Our Case Number: ACP-323799-25

**Re:** Proposed road improvement scheme  
at Newtownmoyaghy Stream, Kilkcok, County Meath.

Meath County Council/An Coimisiún Pleanála Ref TRA 04 023 12  
Newtownmoyaghy Road Improvement Scheme, Newtownmoyaghy,  
Kilcock, Co. Meath

**Observations on the proposed road improvement scheme**

Images/maps reproduced from 'Archaeology Heritage Desk Based Review and Assessment V2', N. Roycroft, July 2024, showing current arrangement of drainage channels.

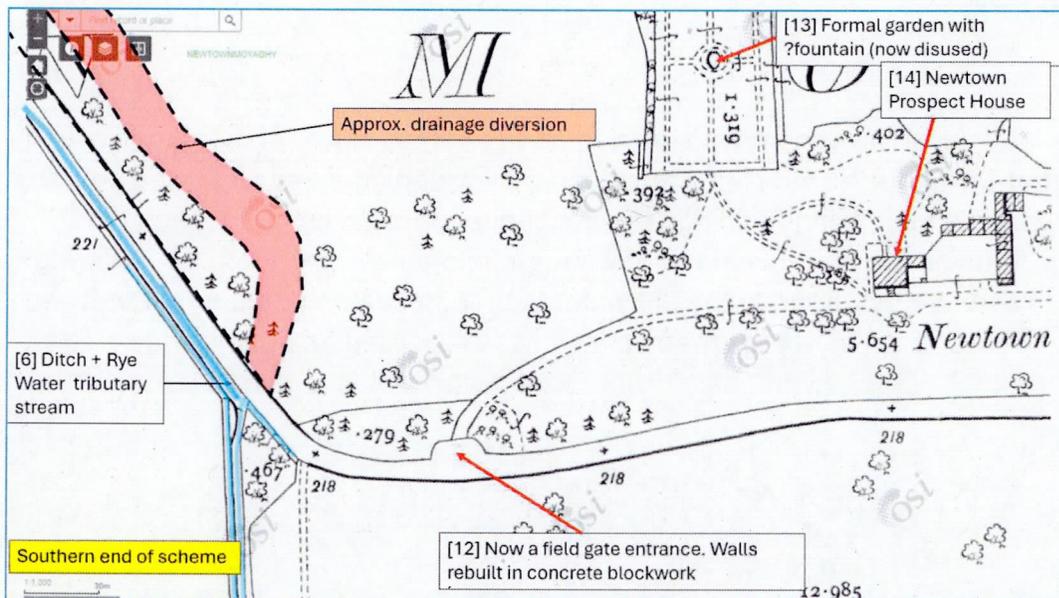
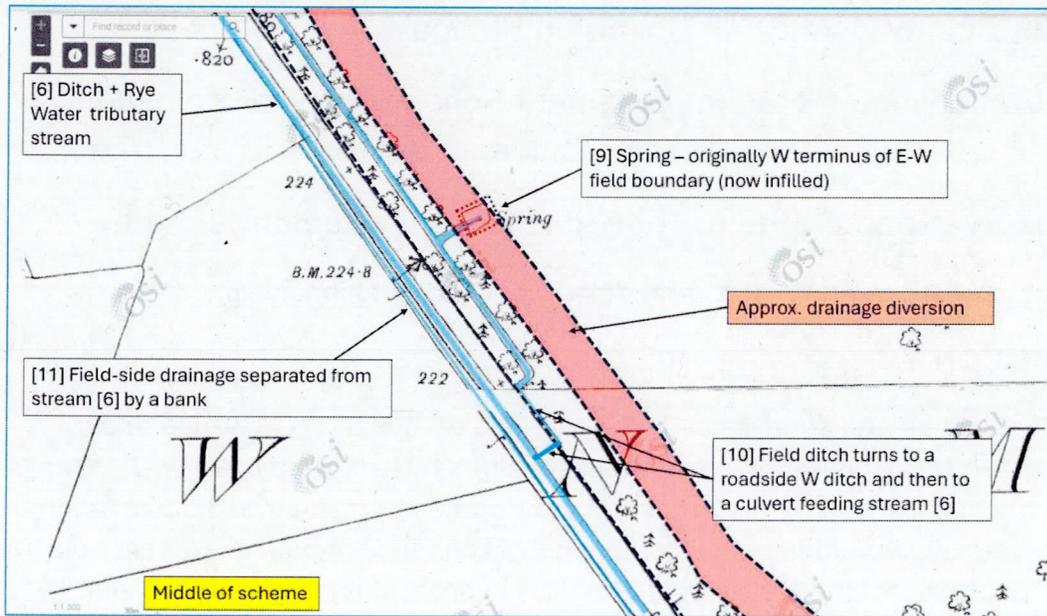
Historically, the road is situated on the floodplain of the adjacent stream, originally bounded by the eighteenth century estate wall on the east side. Parallel field drainage was separated on the east side of the wall, but discharged into the stream via a culvert, as shown on the maps in the Archaeology report, reproduced above. Although the original road was probably a track, some 3m wide, later widening and tarmac sealing has encroached on the floodplain to some 5-6m in width now.
